## COUNCIL ASSESSMENT REPORT

### SYDNEY WESTERN CITY PLANNING PANEL

<b>PANEL REFERENCE &amp; DA NUMBER</b>	PPSSWC-364 (DA-489/2023)
<b>PROPOSAL</b>	<p><i>The development was submitted:</i></p> <p>Demolition of all existing structures, tree removal and construction of a new twelve (12) storey residential flat building consisting of forty-three (43) residential units and two (2) levels of basement car parking. The application is for affordable housing under the State Environmental Planning Policy (Housing) 2021.</p> <p><i>Following RFI, the proposal was amended to 40 residential flat buildings.</i></p>
<b>ADDRESS</b>	LOT A DP 399280, LOT 1 DP 225465 62 & 62A Copeland Street Liverpool
<b>APPLICANT</b>	Chanine Design Pty Ltd
<b>OWNER</b>	VFC Projects Pty Ltd
<b>DA LODGEMENT DATE</b>	12 September 2023
<b>APPLICATION TYPE</b>	Regionally Significant Development
<b>REGIONALLY SIGNIFICANT CRITERIA</b>	Clause 5, Schedule 6 of the State <i>Environmental Planning Policy (Planning Systems) 2021</i> : Affordable Housing

<b>PLAN VERSION</b>	Revision P2
<b>PREPARED BY</b>	Nabil Alaeddine
<b>DATE OF REPORT</b>	12 November 2024

**Figure 16:** Building Height Blanket & Height Penetration (Source: CDA Architects)

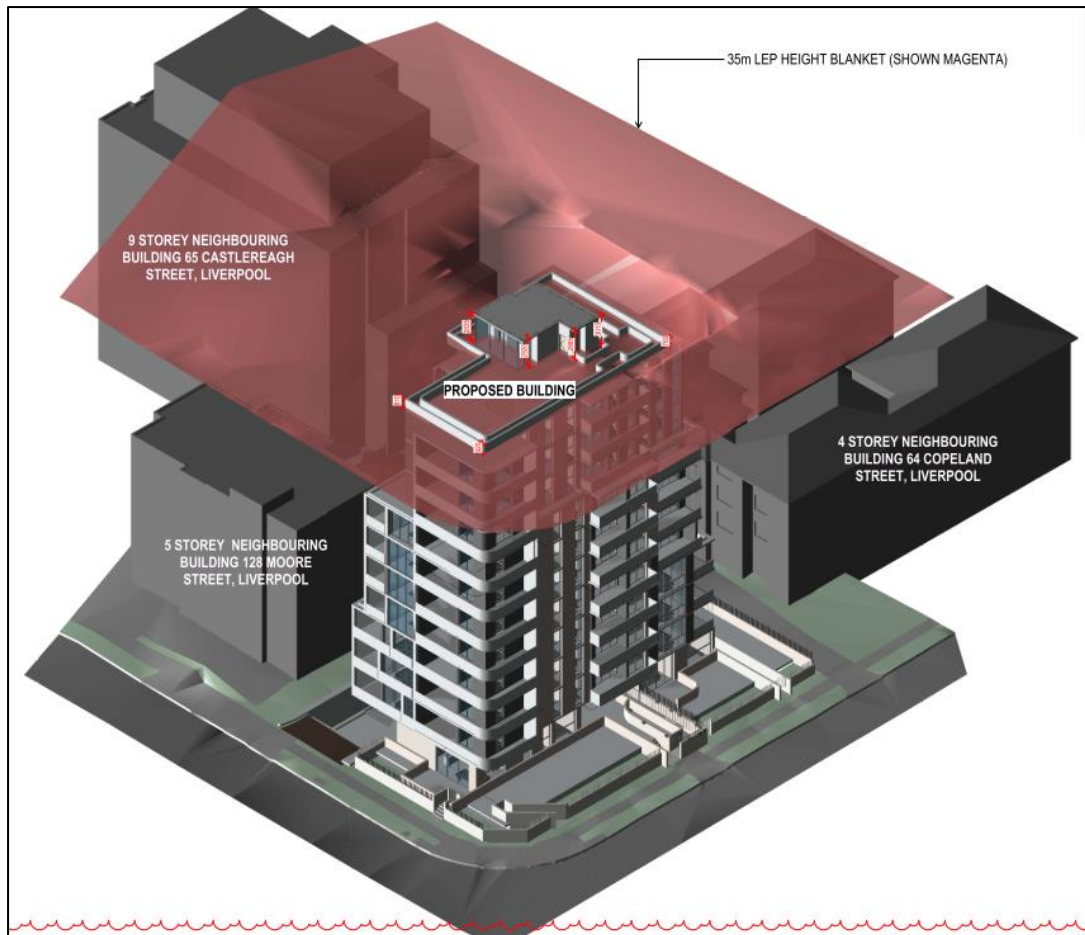
The applicant prepared a Clause 4.6 variation request seeking to contravene Clause 4.3 Height of Buildings under the Liverpool Local Environmental Plan 2008 (LLEP 2008). The subject site is located within an area where the maximum HOB is 35m.

The proposed residential flat building (RFB) will result in a building height of 37.41m – thus exceeding the 35m HOB limit by 2.41m (6.9%). The reasons for this are stated to be due to “lift overrun and a minor portion of the rooftop perimeter planter boxes.” (p4)

Planning is of the opinion that the variation request document accompanying the DA has gone into sufficient detail regarding the HOB non-compliance, specifically that the proposed development will “make a positive contribution to the character of the locality, particularly when viewed from the public domain” and is “compatible with the scale and character of the existing and desired future character of the Liverpool City Centre.” (p7)

**Figure 19:** Northern Elevation of No. 64-68 Copeland Street (Located South of the Subject Site)

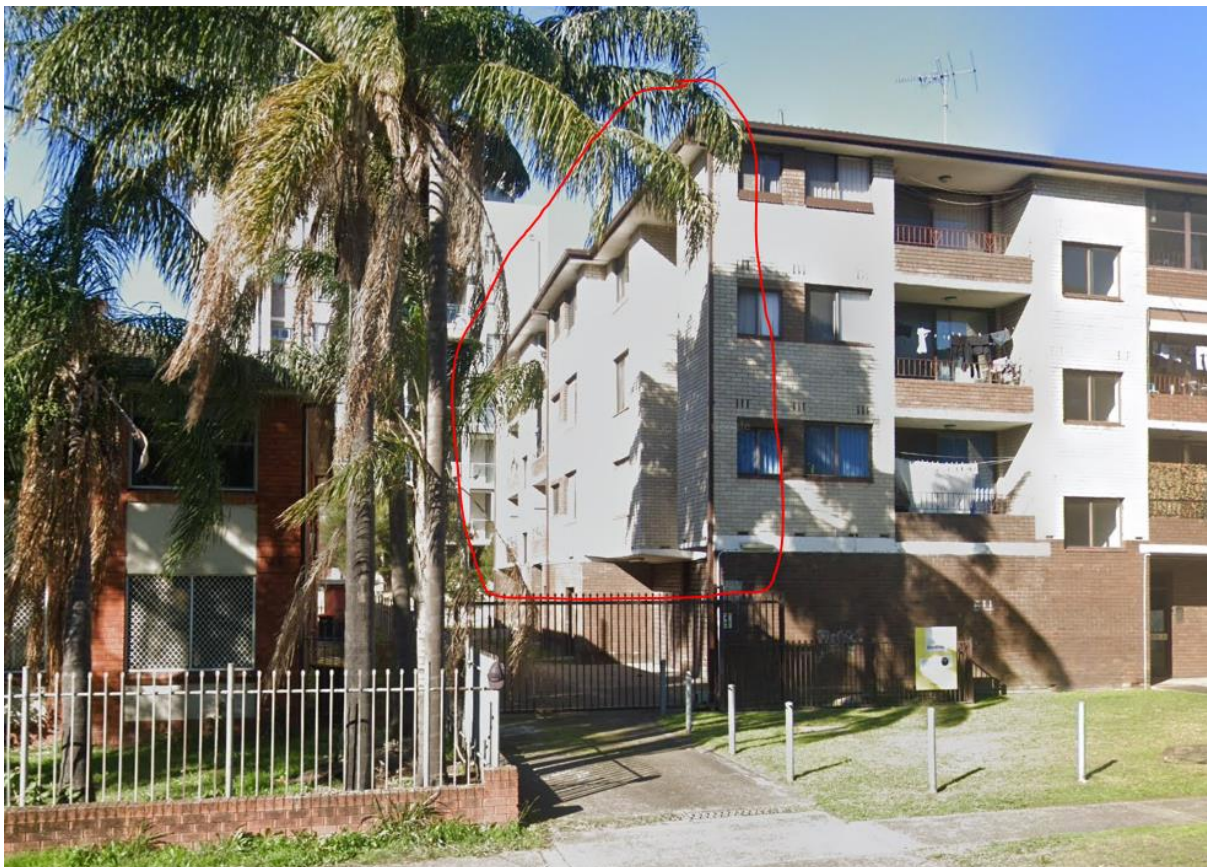
The aim of the proposal is to provide as many privacy mitigation measures and to reduce any potential overlooking by designing the southern façade with these matters in mind. Figure 17 below shows the proposed message on the south façade which includes highlight windows, and privacy screens on balconies

**Figure 20:** Typical Floor level showing location of balcony extrusion into the front setback.

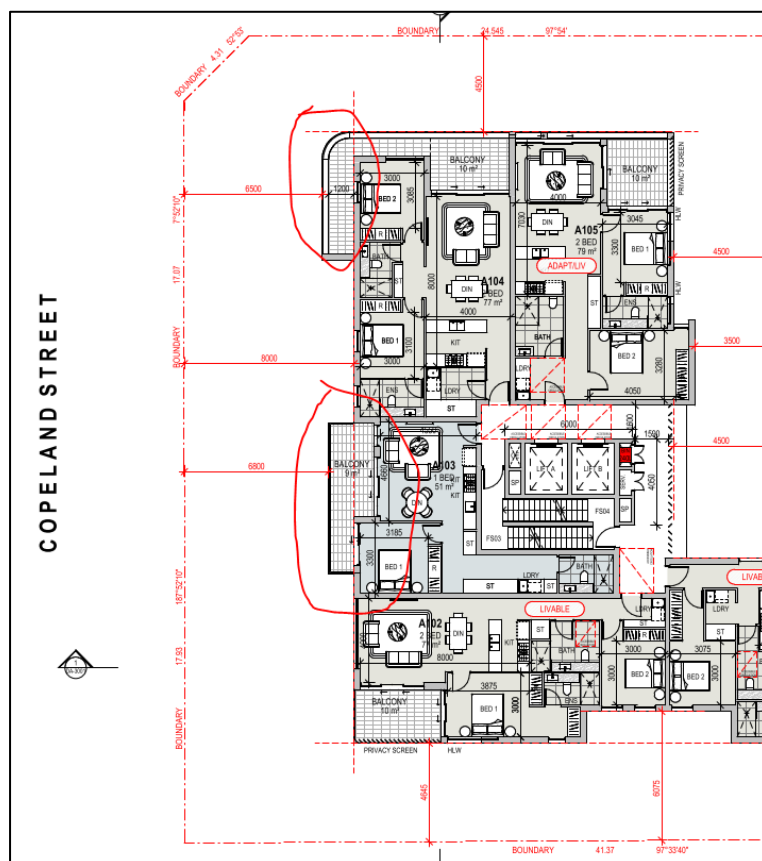
Section 4.2.7 of the Liverpool DCP 2008 requires an 8-metre landscaped setback to buildings with a boundary to the Hume Highway (Copeland Street). The proposal provides a front setback ranging from 8m only on the ground floor level with balconies protruding into the articulation zone reducing the setback to Copeland Street to 6.8 meters. However, this is not for the entire length of the building and is only concentrated along the length of two balconies from levels 1 to 10 (Figure 20 below).

The proposed setbacks are considered satisfactory having regard to the following:
